**Re: Niagara Peninsula Energy Inc. (Niagara Peninsula Energy)
2021 Cost of Service Rate Application
Ontario Energy Board (OEB) File Number: EB-2020-0040**

OEB Staff Interrogatories
2021 Electricity Distribution Rates Application
Niagara Peninsula Energy Inc. (Niagara Peninsula Energy)
EB-2020-0040
October 28, 2020

The graph below shows the correlated historical and forecasted relationship between System Access expenditures and Capital contributions (based on page 296 and 299)

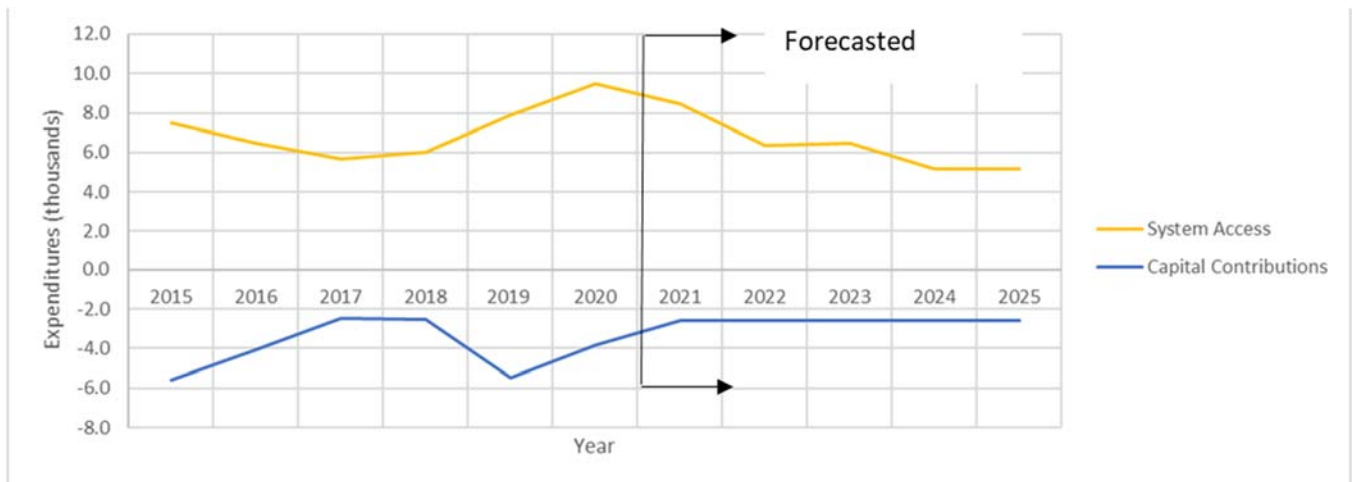
In the historical period (2015-2019), the average Capital Contribution as a percentage of System Access is 58%, whereas in the forecast period (2021 to 2025) the average is 42%.

Ref 1: Exhibit 2, Appendix 2-8, Distribution System Plan, Projects Table Reference #53 Pole Replacement Program, Page 393 of 1059

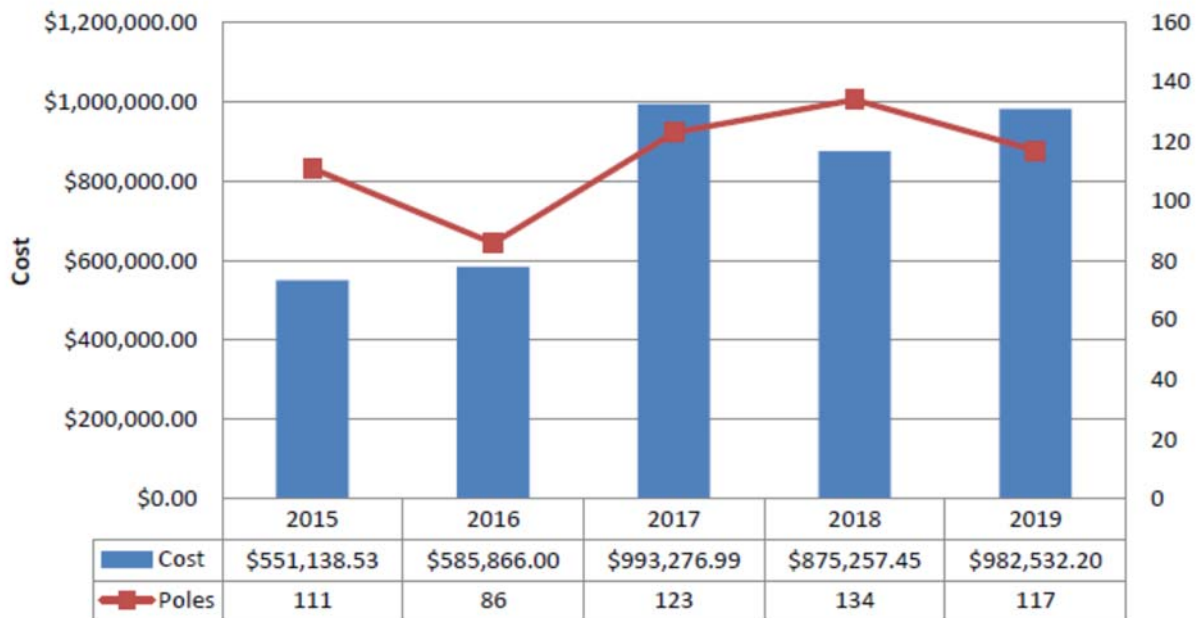
Niagara Peninsula Energy stated that “The table below summarizes the pole replacement program from 2015 to 2019. Over this period, the average cost to replace a pole was \$6,841.”

The following table shows the average cost per year to replace poles between 2015 and 2019:

Ref 1: Exhibit 2, Appendix 2-8, Distribution System Plan, Appendix 2-AA Capital Projects Table Reference #54 Kiosk Replacement Program with Pad Mounted Transformers, Page 364 of 1059

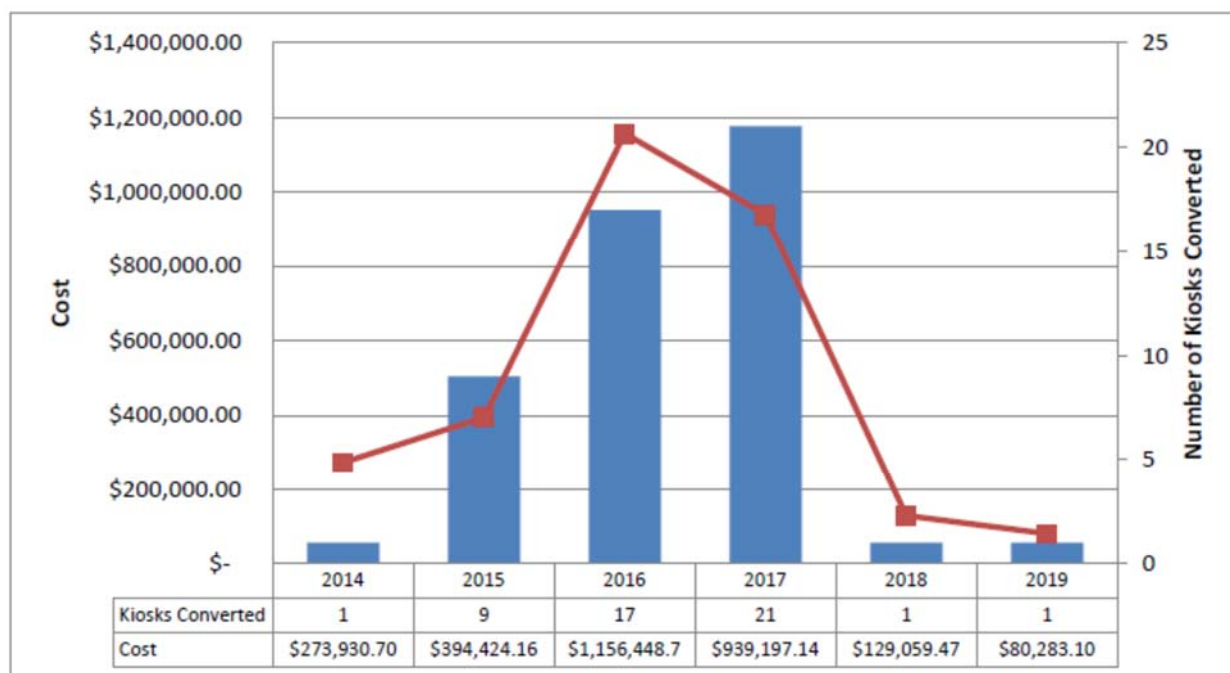
- Please confirm the number transformers that will be replaced in these kiosks and are they considered pad mounted transformers.
- Please show the calculation that Niagara Peninsula Energy used to derive its average cost of \$55,061.91 per kiosk?
- What is the range of costs per kiosk that Niagara Peninsula Energy has experienced in the past?
- Niagara Peninsula Energy has stated that the cost can vary from kiosk to kiosk as each project is unique. Can you please explain how the capital expenditure request for the 11 kiosks are estimated?
